UNITED STATES PATENT AND TRADEMARK OFFICE

Office Action Summary	Application No. 10/695,253	Applicant(s) HONG ET AL.	
	Examiner Burton S. Mullins	Art Unit 2834

DETAILED ACTION

Sheet 6 of 14

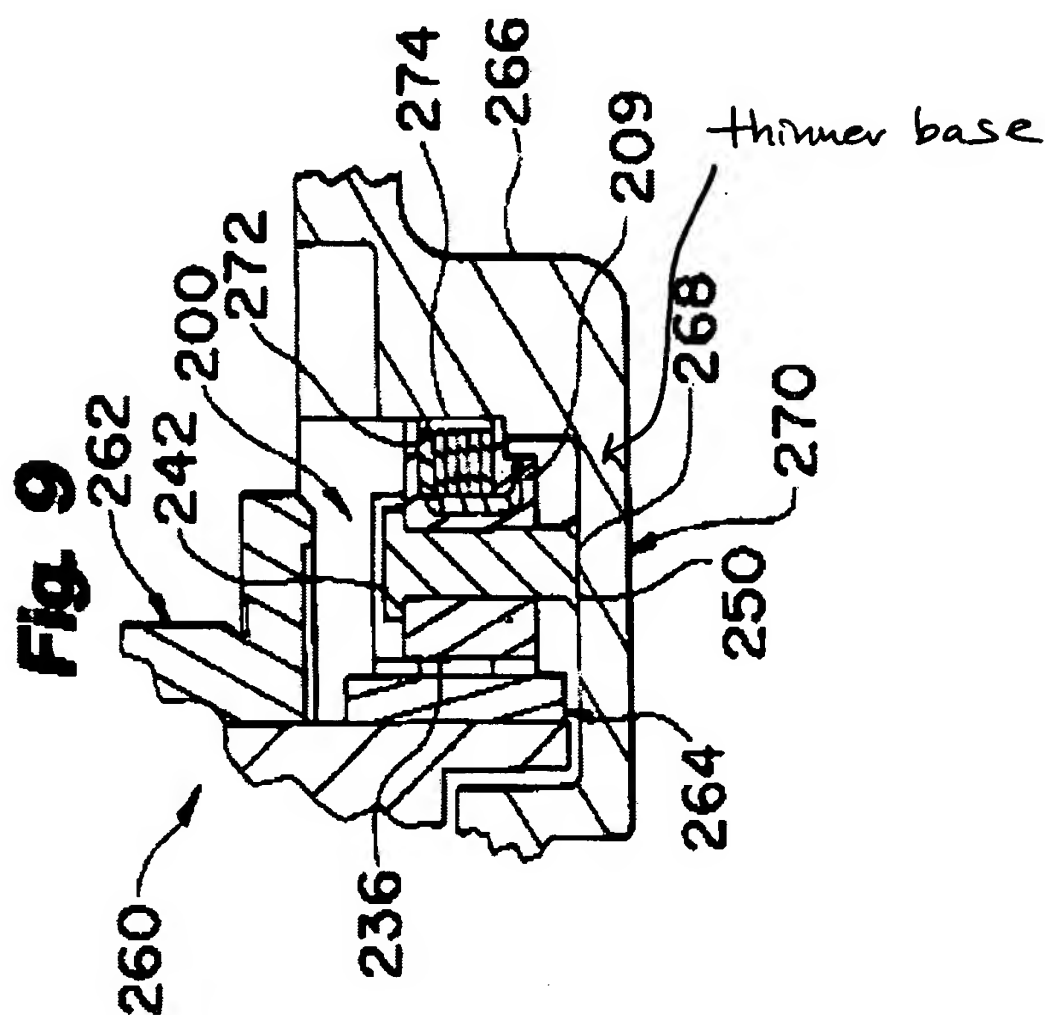
3. Claims 1, 7-9, 15-17, 20 and 22 are rejected under 35 U.S.C. 102(b) as being anticipated by Dunfield et al. (US 5,694,268). Dunfield teaches a spindle motor comprising: a rotatable component 36 defining a bearing gap and relatively rotatable with a stationary component 34; a base plate 12 affixed to the stationary component; a stator 38, affixed to the stationary component, for generating an electromagnetic force that interacts with a magnet 70 affixed to the rotatable component and drives the rotatable component, wherein the stator 72 and the base plate 12 define a separation there between (not numbered, Fig.2), and wherein the stator 38 is situated radially outside the magnet 70 (Fig.2); a motor seal (flux shield) 82/292 situated radially outside the magnet and positioned axially above the stator (Figs.2&11; the flux shield is a "seal" in the sense that it covers the top of the stator); and a bonding substance 209 (overmold comprising rubber/plastic material, c.8:12-19; Figs.8-11) formed substantially about the stator, substantially filling the separation and uniting the base plate 266, the motor seal 292 and the stator (Fig.11),

wherein the base plate axial thickness is minimized adjacent to the separation (as seen in Fig.9, base is thinner adjacent the separation than at outside perimeter thereof).

Regarding claims 7 and 15, a portion of the base plate adjacent to the separation defines an opening that is substantially filled with the bonding substance 209, and the bonding substance forms a contiguous base plate 266, i.e. the two parts are in contact or integrated.

Regarding claims 8 and 16, a portion of the stator is positioned below an adjacent surface of the base plate, wherein the base plate has a varied axial thickness (see Fig.9 above).

Fig. 7

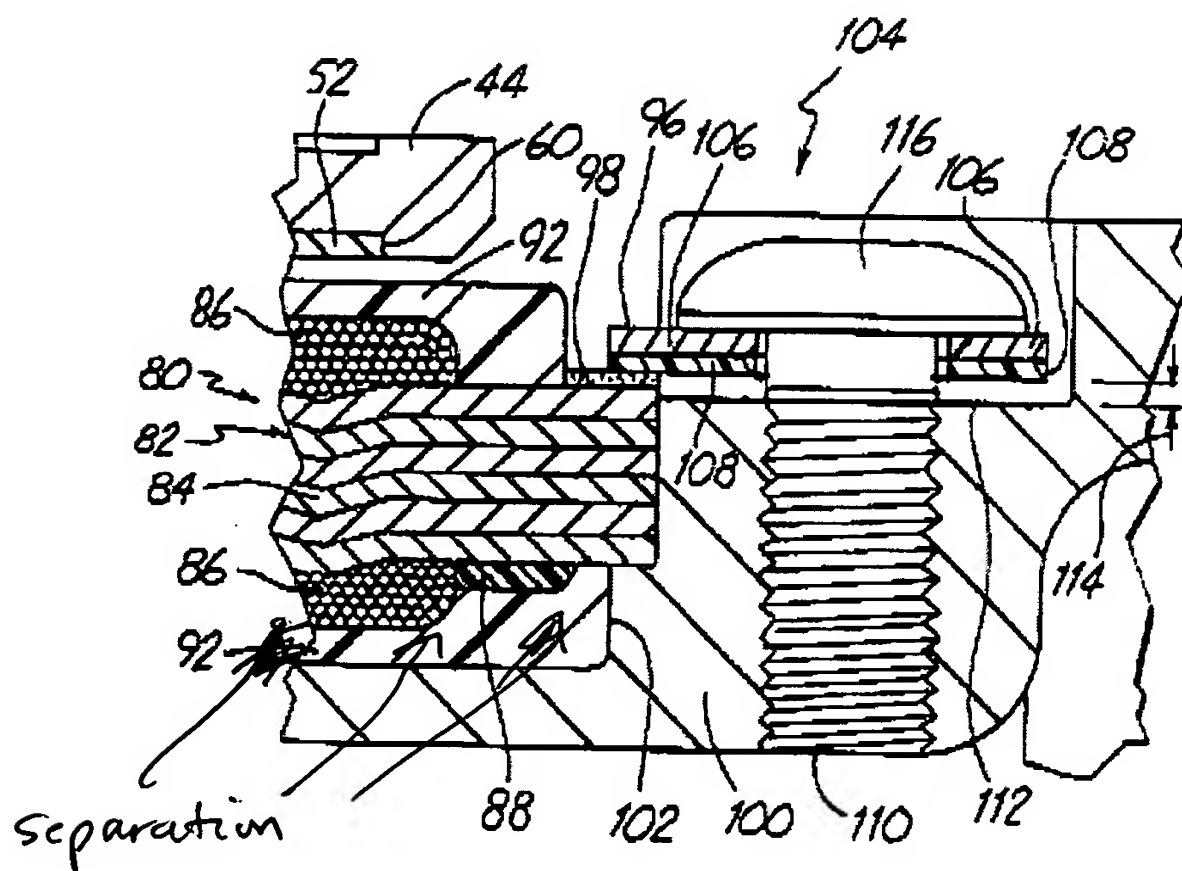
5. Claims 1, 7-9, 14, 16, 17, 20 and 22 are rejected under 35 U.S.C. 102(e) as being anticipated by MacLeod et al. (US 6,282,053). MacLeod teaches a spindle motor comprising: a rotatable component 40/42 defining a bearing gap (with bearings 24) and relatively rotatable with a stationary component (shaft) 20 (Fig.2); a base plate 100 affixed to the stationary component; a stator 80 affixed to the stationary component, for generating an electromagnetic force that interacts with a magnet 46 affixed to the rotatable component 40/42 and drives the rotatable component, wherein the stator 80 and the base plate 100 define a separation there between (not numbered, Fig.7), and wherein the stator 80 is situated radially outside the magnet 46 (Fig.2); a motor seal (comprising overmold) 92 situated radially outside the magnet 46 and positioned axially above the stator 80 (Fig.7); and a bonding substance (plastic overmold) 92, formed substantially about the stator 80 (c.5:28-48; Figs.4-5&7), substantially filling the separation and uniting the base plate 100, the motor seal 92 and the stator 80, wherein the base plate axial thickness 100 is minimized adjacent to the separation (inherent).

Regarding claims 7 and 14, the opening adjacent the separation is filled with bonding substance 92 (Fig.7).

Regarding claims 8 and 16, as seen in Fig.7, a portion of stator 80 (e.g. windings 86) is below an adjacent surface of the base plate 100, the base plate 100 having varied axial thickness (stepped structure, Fig.7).
